Work Order ID 151640

Item Name: Amends Installation of D350-591-311/-312 Steps

DART SERVICE INSTRUCTION

TO AMEND DRAWING D350-591 REV. F
REF. CANADIAN STC: SH92-6
FAA STC: SH967NE

FIGURE 1 - CLAMP/CUSHION INSTALLATION

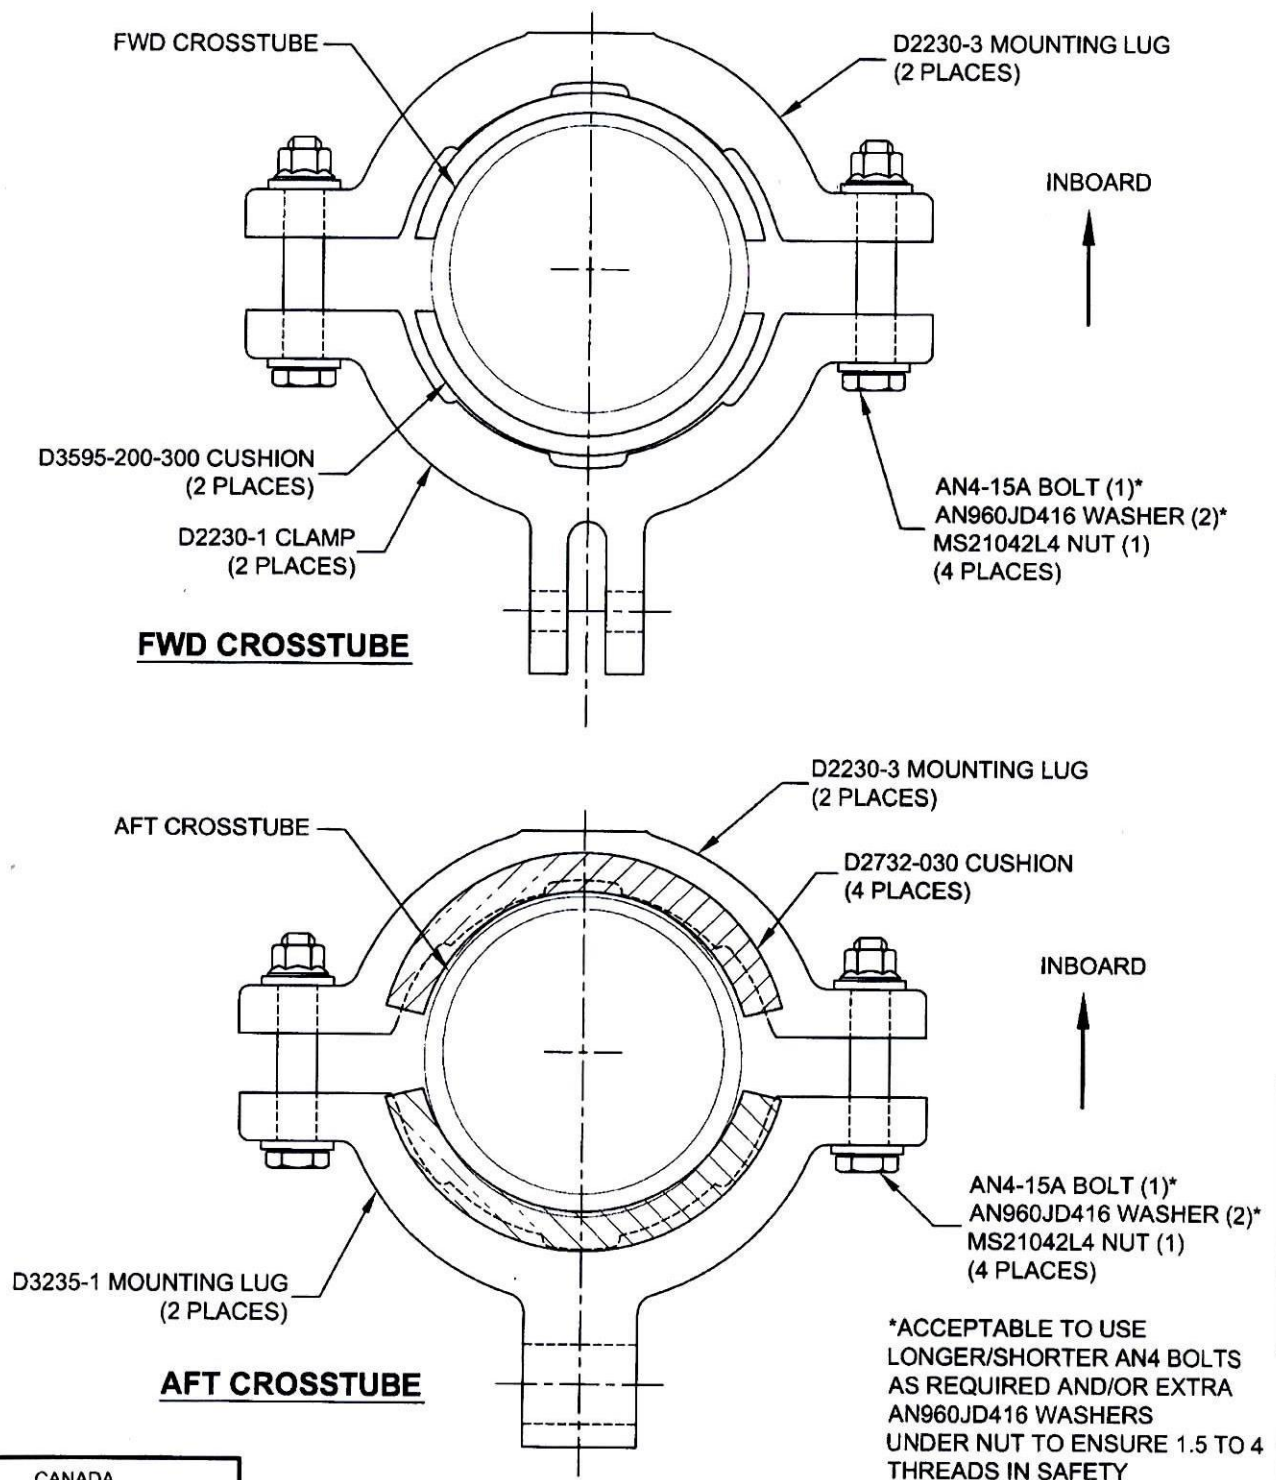
TO IMPROVE THE FIT OF THE D350-591-311/-312 STEPS, IT IS ACCEPTABLE TO INSTALL THE DSI 9410-011 KIT. INSTALL THE D2732-030 CUSHION (AFT CROSSTUBE) AND D3595-200-300 CUSHION (FWD CROSSTUBE) AS SHOWN IN FIGURE 1 IN PLACE OF THE D2856-400-720 ABRASION STRIP CALLED OUT ON DRAWING D350-591 REV. F.

FOR CUSTOMERS WHO HAVE PREVIOUSLY INSTALLED D2856-400-720 ABRASION STRIPS REMOVE THE ABRASION STRIPS IN ACCORDANCE WITH ICA-D350-591. PRIOR TO INSTALLING THE DSI 9410-011 KIT.

DSI 9410-011 KITS WILL BE INCLUDED WITH D350-591-311/-312 STEPS AT CHANGE 002 AND SUBSEQUENT.
